COLLETON PLACE SUBDIVISION

The purpose of this application is to create a 148-lot subdivision from one lot.

Revised for the January 18th meeting:

DETAIL SITE PLAN

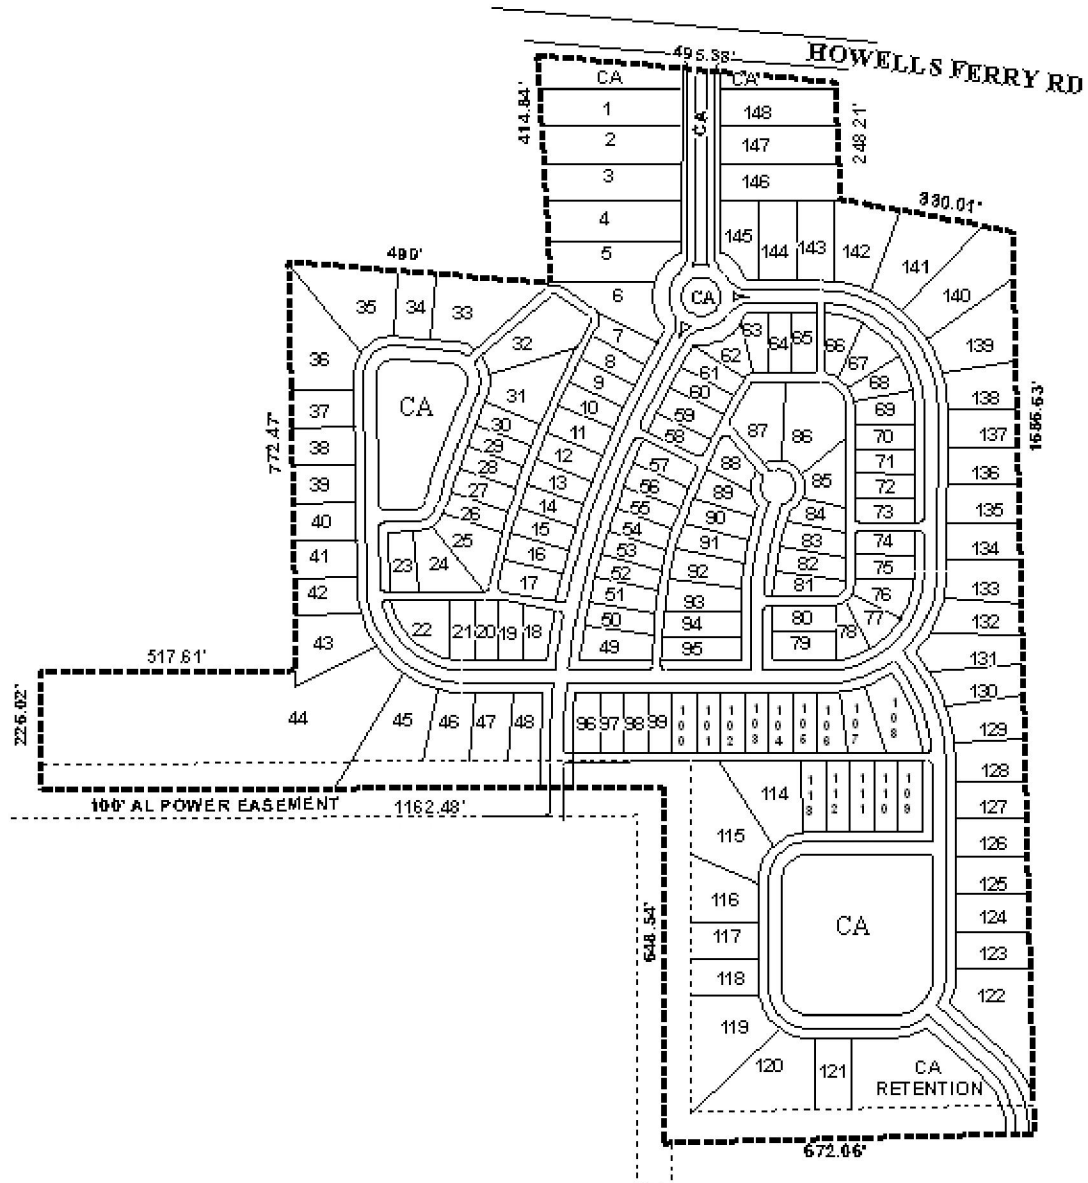
Access management is a concern as it relates to public safety. The subdivision, as proposed, will have only one connection to a public street. Street-stubs are proposed at two locations on the South side of the site, but there are no connections to other streets immediately accessible from the street-stubs, thus access to other public streets will not occur within the near future. At least one additional connection to an existing public street would improve accessibility for emergency vehicles.

It appears that many of the corner lots do not comply with Section V.D.5. of the Subdivision Regulations; specifically, their widths are not adjusted to accommodate the required minimum building setback from both streets, thus the resulting buildable area width may not be sufficient.

Common areas are proposed within the round-about, a road median, and as “park” and detention areas. A note should be placed on the final plat, if approved, stating that maintenance of the detention and common areas is the responsibility of the subdivision’s property owners.

Stormwater detention facilities are depicted on the plat. While the site is located in the county, compliance with the City of Mobile stormwater and flood control ordinances will be required. A letter from a licensed engineer certifying compliance with the City’s stormwater and flood control ordinances should be submitted to the Planning Section of Urban Development prior to the signing of the final plat, if approved.

The proposed 15-foot minimum building setback line will require a waiver of Section V.D.9. of the Subdivision Regulations. Also, a waiver of Section V.D.3. will be required for proposed lot 44 due to its extreme depth.

With a waiver of Section V.D.2. for minimum lot size requirements, Section V.D.9. for building setbacks and Section V.D.3. for lot 44, this application is recommended for Tentative Approval, subject to the following conditions: 1) provision of a certification letter from a licensed engineer to the Planning Section of Urban Development, certifying that the stormwater detention, drainage facilities, and release rate comply with the City of Mobile stormwater and flood control ordinances, prior to the signing and recording of the final plat; 2) placement of a note on the

plat stating that the approval of all applicable federal, state and local agencies will be required prior to the issuance of any permits or land disturbance activities if wetlands occur on the site; 3) labeling of all common areas (including detention), and placement of a note on the plat stating that maintenance of any common areas is the responsibility of the subdivision's property owners; 4) revision of the plat so that each lot contains a minimum of 5,000 square feet; 5) revision of the plat to label each lot in square feet, or provision of a table on the plat depicting the same information; 6) placement of a note on the plat stating that direct access for lots and common areas onto Howells Ferry Road is denied; 7) depiction of the 15-foot minimum building setback line on the plat; 8) placement of a note on the plat stating that any lots which are developed commercially and adjoin residentially developed property must provide a buffer, in compliance with Section V.A.7. of the Subdivision Regulations; and 9) placement of a note on the plat stating that maintenance of the alleys shall be the responsibility of the property owners.

TYPICAL LOT LAYOUT

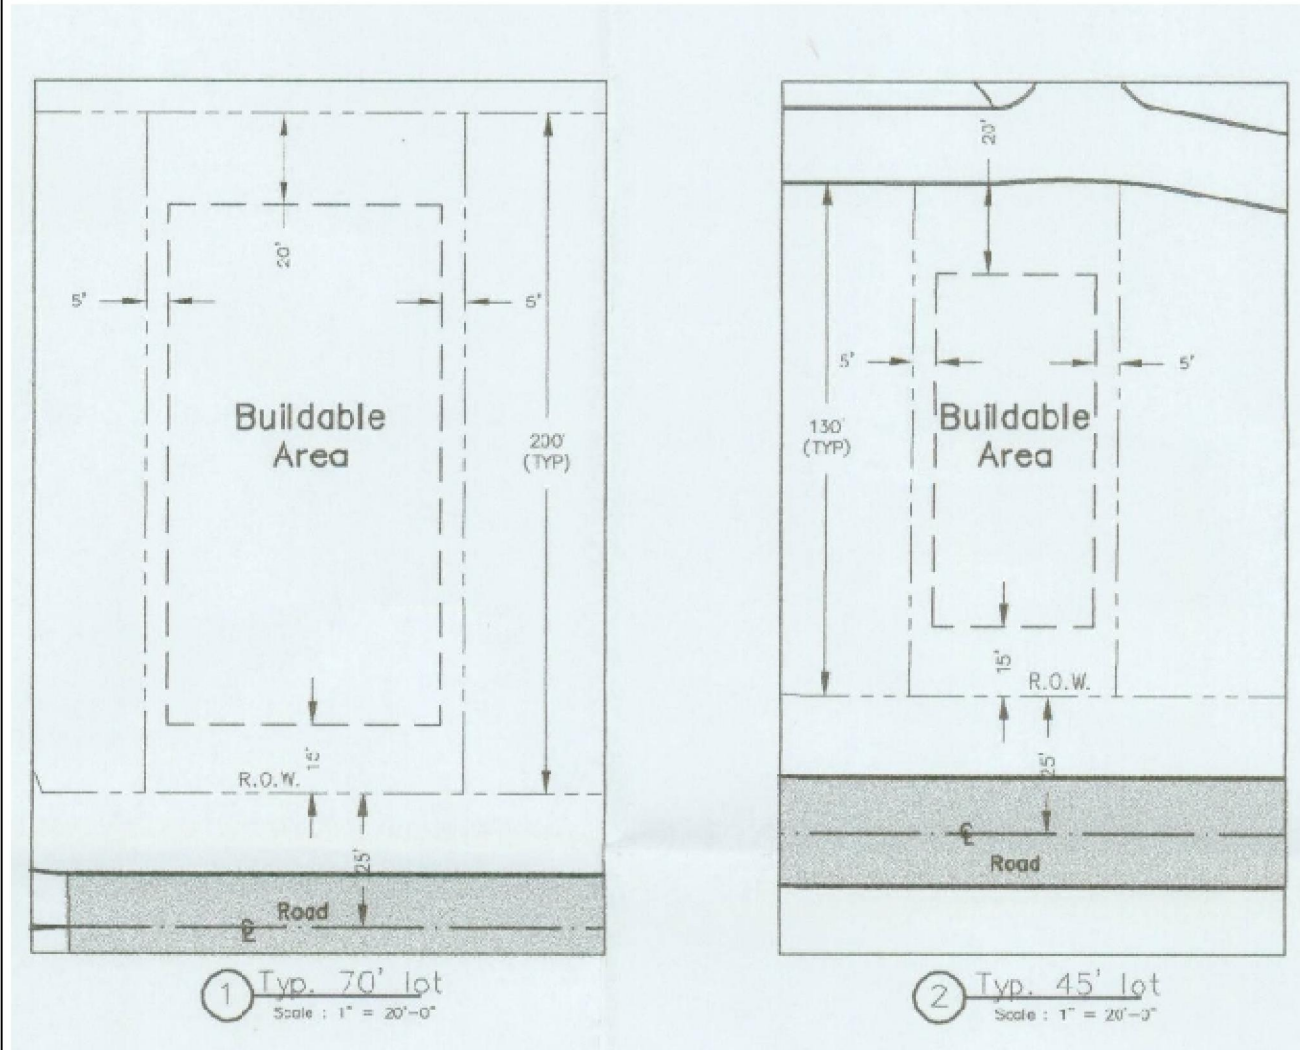
The proposed lot sizes, setbacks, alleys and common areas indicate that the applicant is attempting an “innovative” subdivision, however, no specific statement to this end has been provided by the applicant. While innovative subdivisions that embody traditional neighborhood development design elements are encouraged, the site is far removed from public transit service and is a “greenfield site” - a site that is currently minimally developed. It should also be pointed out that some of the proposed lot sizes and lot widths do not meet the minimum width or size requirements of Sections V.D.2. of the Subdivision Regulations. If it is the applicant’s intent to invoke innovative design or traditional neighborhood design consideration, the applicant should provide a statement indicating the design intent for the subdivision, if innovative under Section VIII.C. of the Subdivision Regulations, or revise the subdivision so that all lots meet minimum standards.

The plat has a note stating that of the 46.59 acres, 16.67 acres will be devoted to “parks,” power easement and road right-of-way. The remainder of the property, 29.92 acres, will be allocated to the 148 lots, which results in an average lot size of approximately 8,806 square feet. Staff has estimated a minimum lot size of approximately 4,700 square feet.
